Addendum 2
To Contract Documents for

Kate Furbish Elementary Discovery Classroom

Kate Furbish Elementary – Discovery Classroom
Brunswick, ME
Addendum #2
04/17/2020

DRAWN: MPV	DATE: FEBRUARY 25, 2020
DESIGNED: ADJ	SCALE: 1" = 10'
CHECKED: ADJ	JOB NO. 17-035
FILE NAME:	
SHEET: C-1

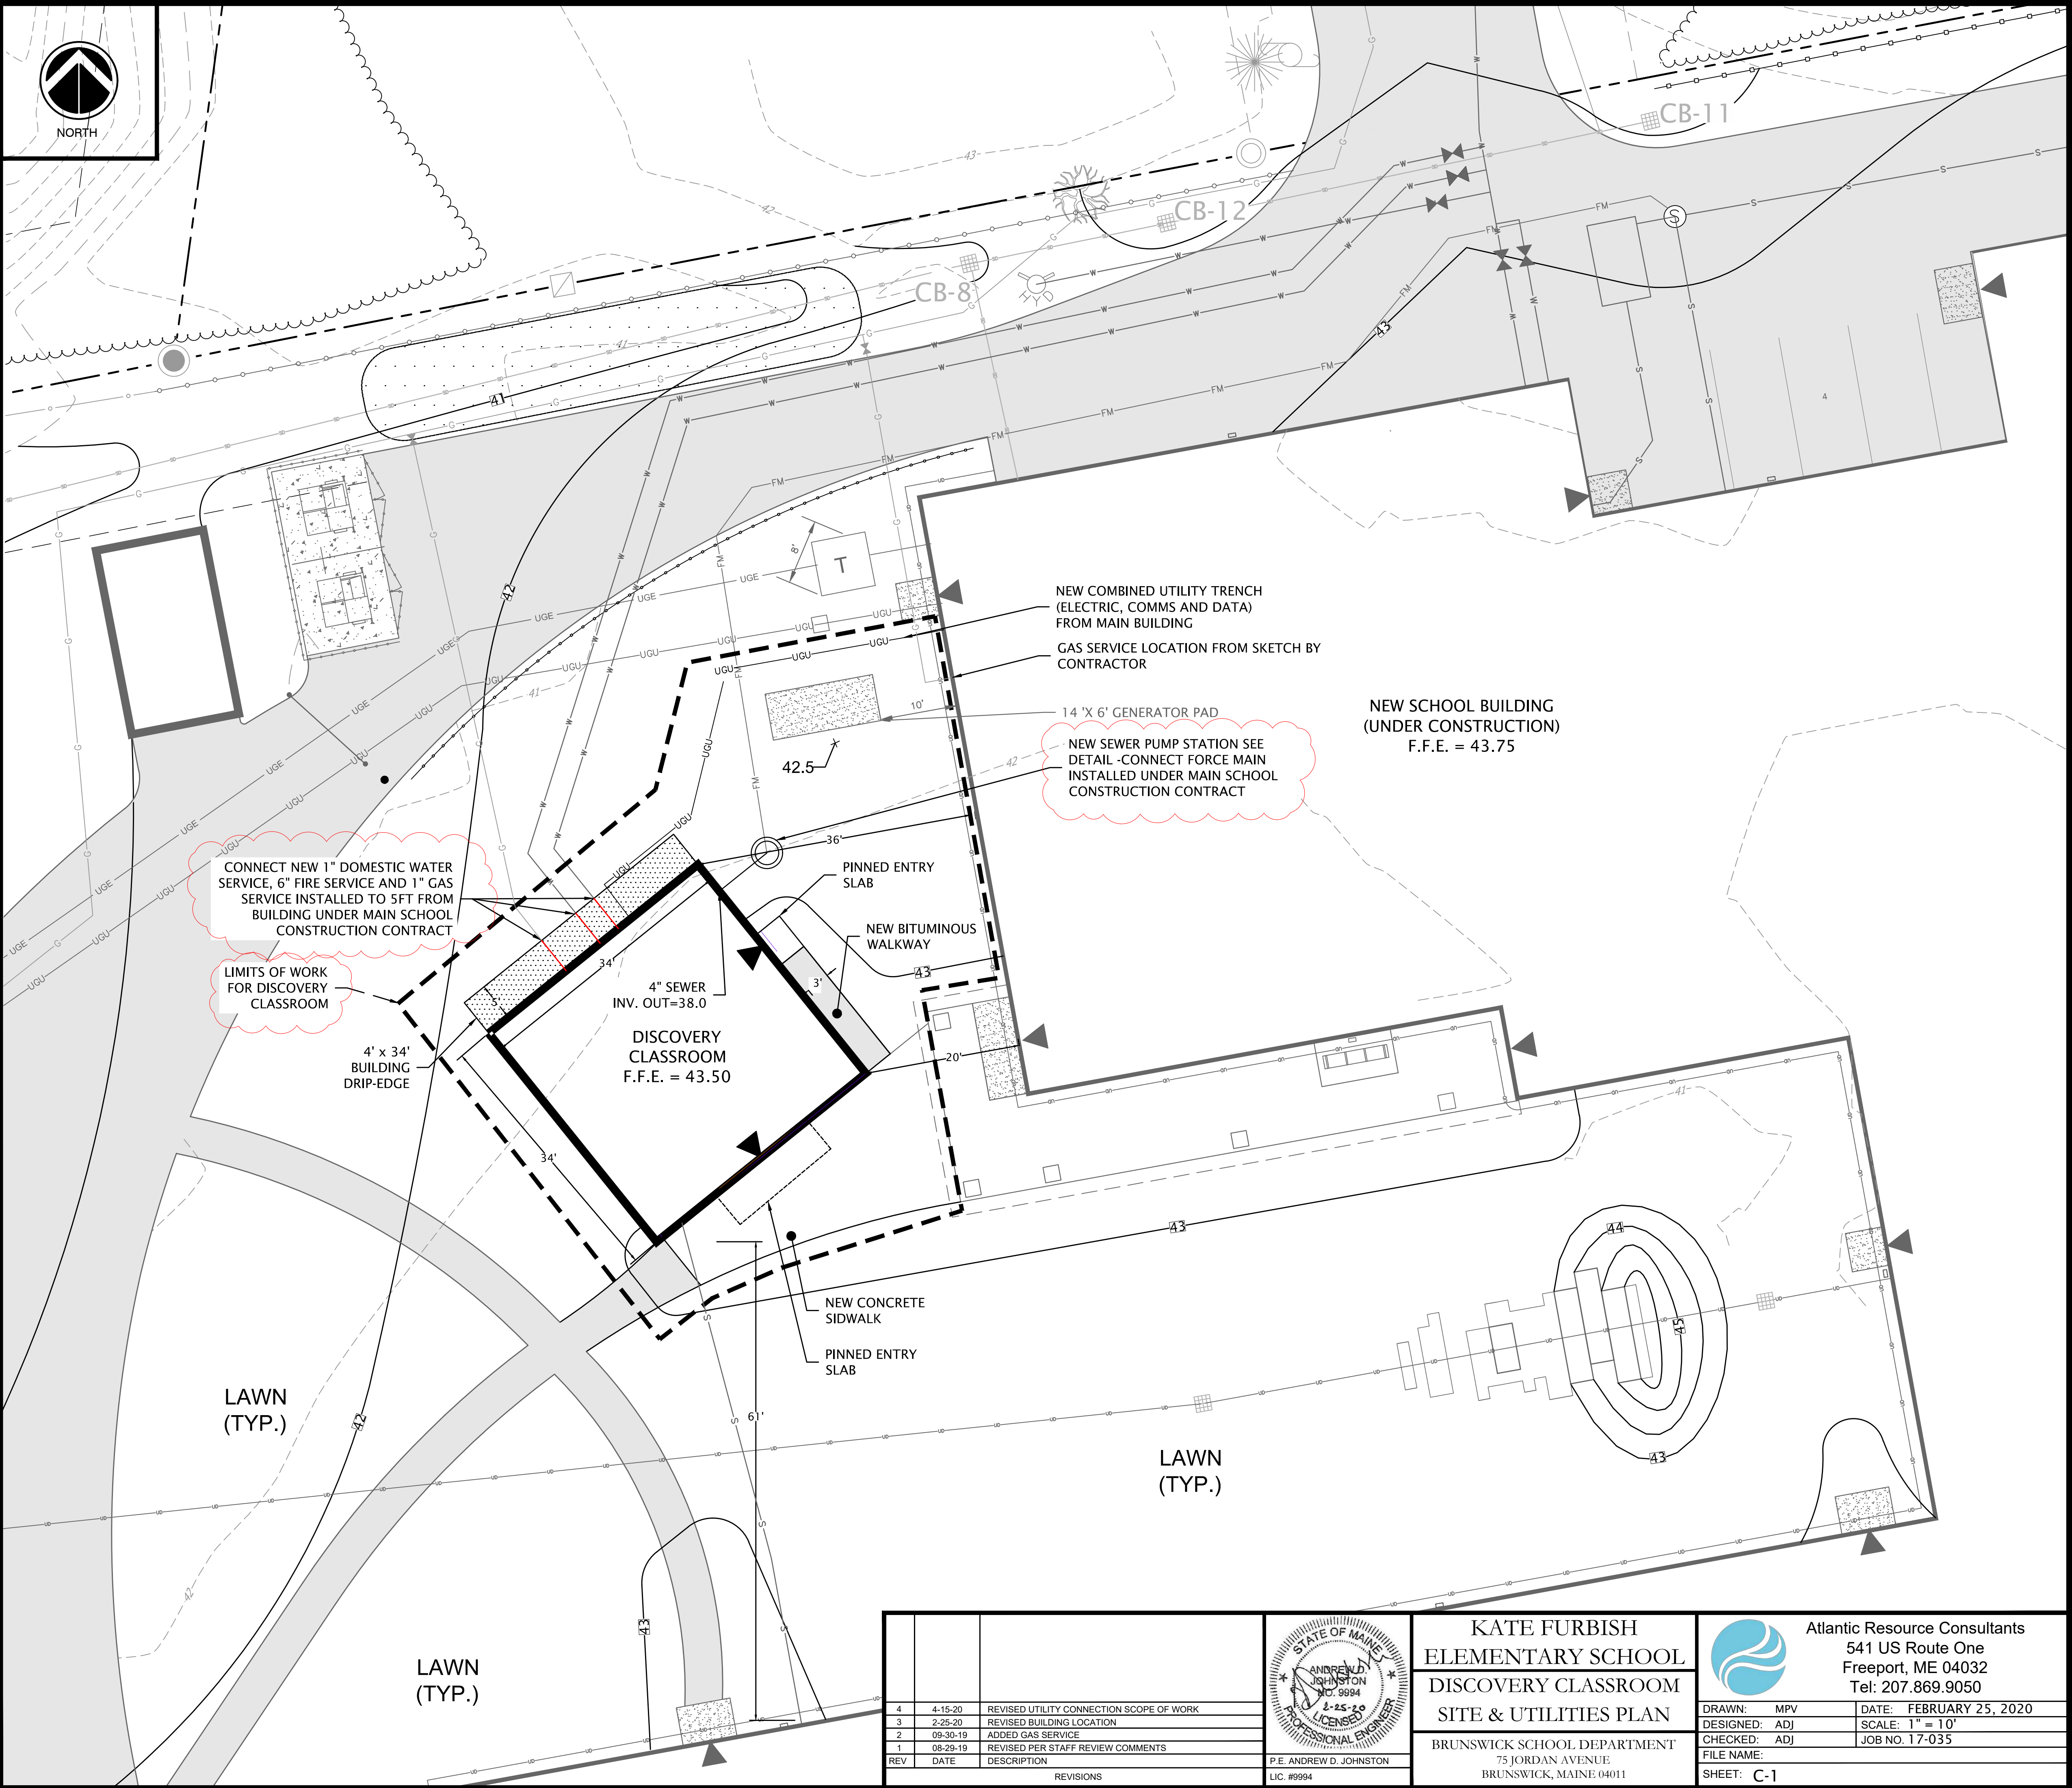
- Q.** Is the new driveway work completed so we are saw cutting pavement and patching in the driveway areas?
A. Please see clarification to scope of work in Part I Addendum to Civil Specifications and Drawings.

- Q.** Could you please indicate the locations for Data and Fire Alarm conduits?
A. The data and fire alarm conduits should originate from the main building Electrical room to the Classroom building following the same path as the power conduit marked as indicated on drawing C-1.

- Q.** Drawing C-1 indicates that new underground electrical conduit shall be from the discovery center towards main electrical rm. E101, note 20, indicates that power shall be fed from panel LP2 which is in A Wing, Elec Rm 126. Is the intent to install conduit inside the building from main Elec rm to Elec rm 126? Or should the route change?

- Revise utility connection scope of work as indicated on drawings.

- A.** Revise Note 20 as follows:
“Provide 100A/3P fused disconnect in main Electrical Room 153 located in Main Building to feed Panel DCP-1. Disconnect shall be added on secondary side of existing 150KVA DTT in the main electrical room 153. Contractor shall add wireway and tap existing feeder for new 200A disconnect mount adjacent to 400A disconnect feeding LP Feeder Size shall be - 4 #1, 1 #6 gnd, in a 4”C.”

HEAVY DUTY PAVEMENT DETAIL

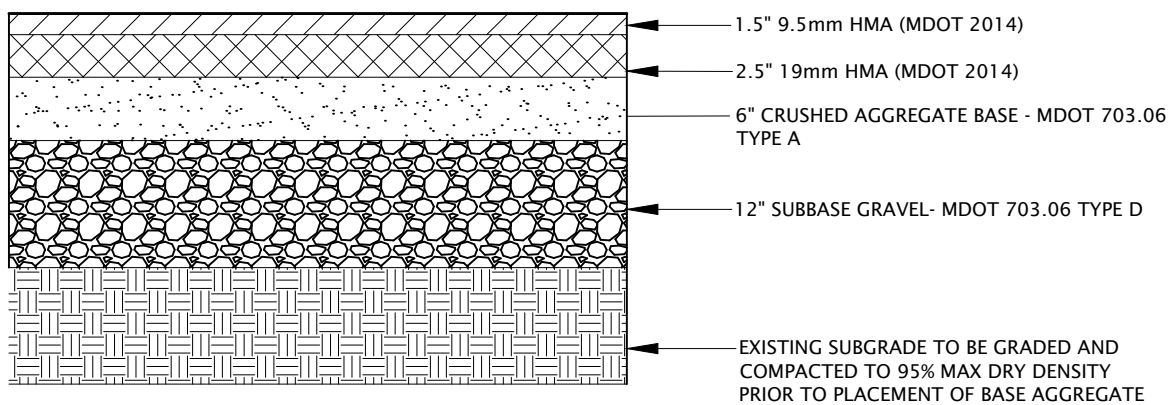
- Q.** There is no detail for the pavement or gravel thickness in the driveway. Even if there is no paving to do I need gravel depth. Assuming 18".
A. Please see Part I Addendum to Civil Specifications and Drawings for clarification.

- Add heavy duty pavement detail per **SK-I**.

1 ROOF PLAN
3/8" = 1'-0"

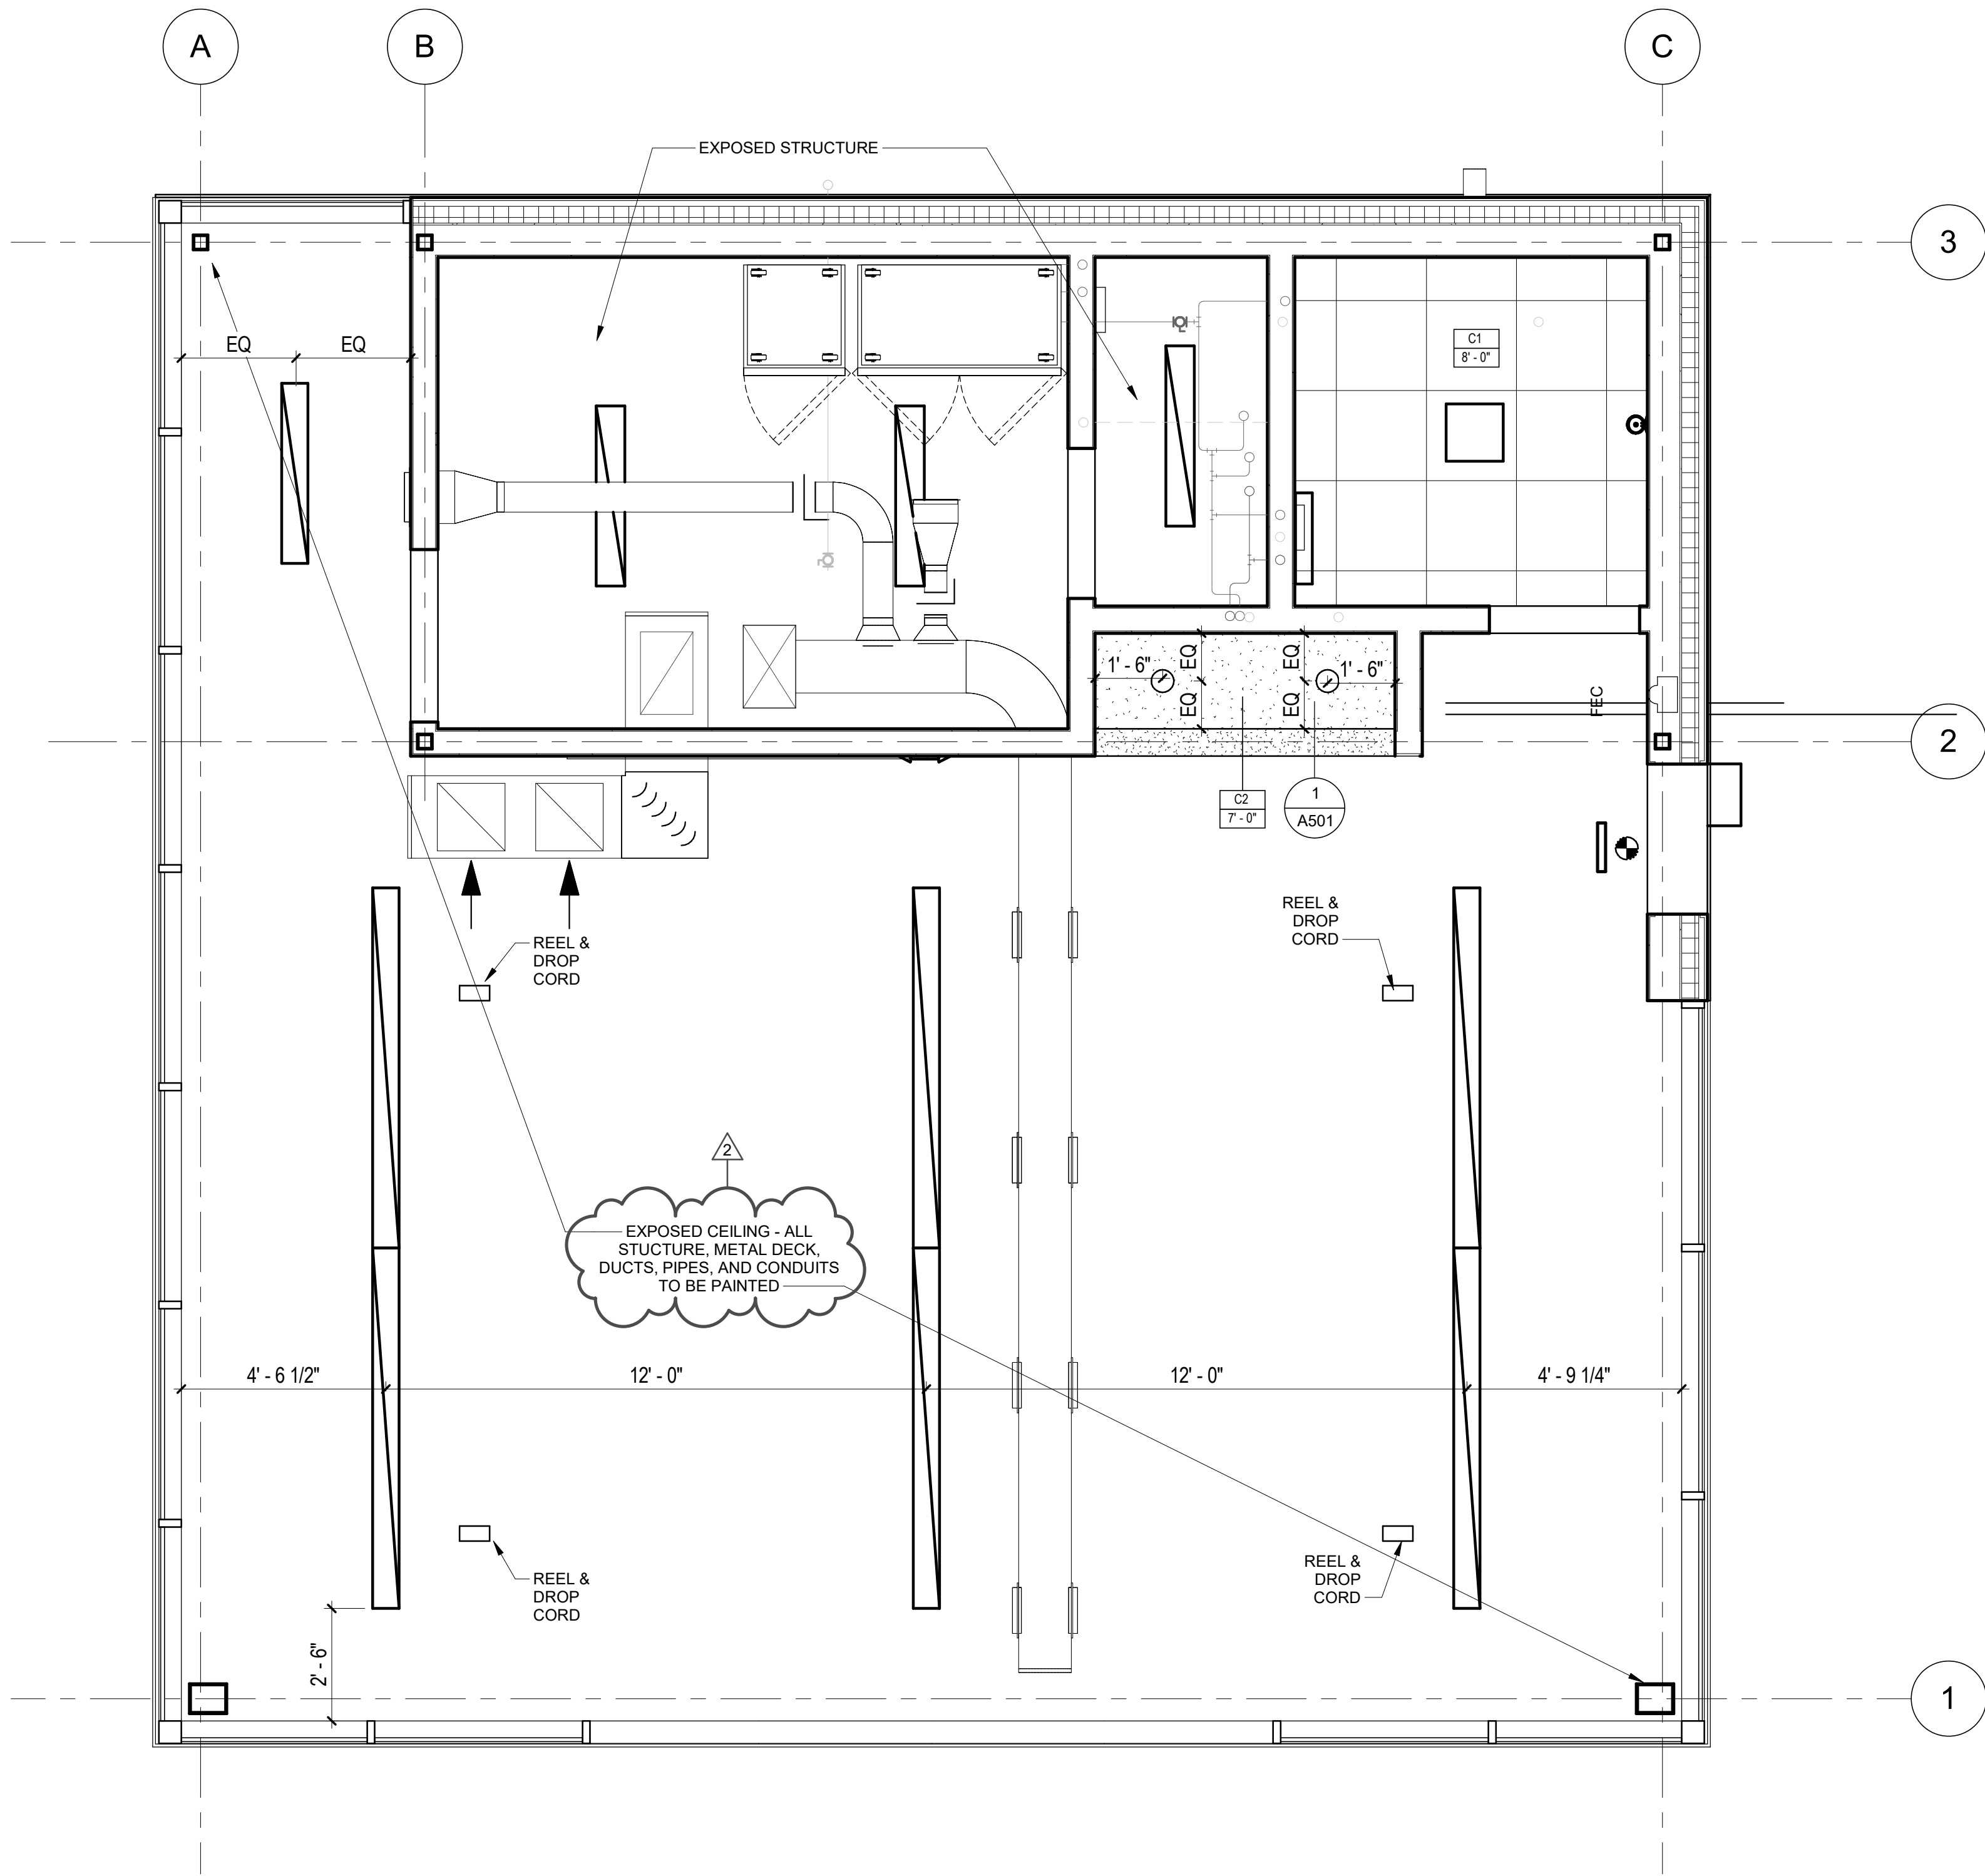
- A.** Exposed structure in rooms Storage 101 and Utl. 101A are to be left raw. All other exposed structure to be painted. See Part III Addendum to Architectural Specifications and Drawings for further clarification.

- Revise note from “Exposed structure, painted” to “Exposed ceiling – all structure, metal deck, ductwork, pipes and conduits to be painted.”
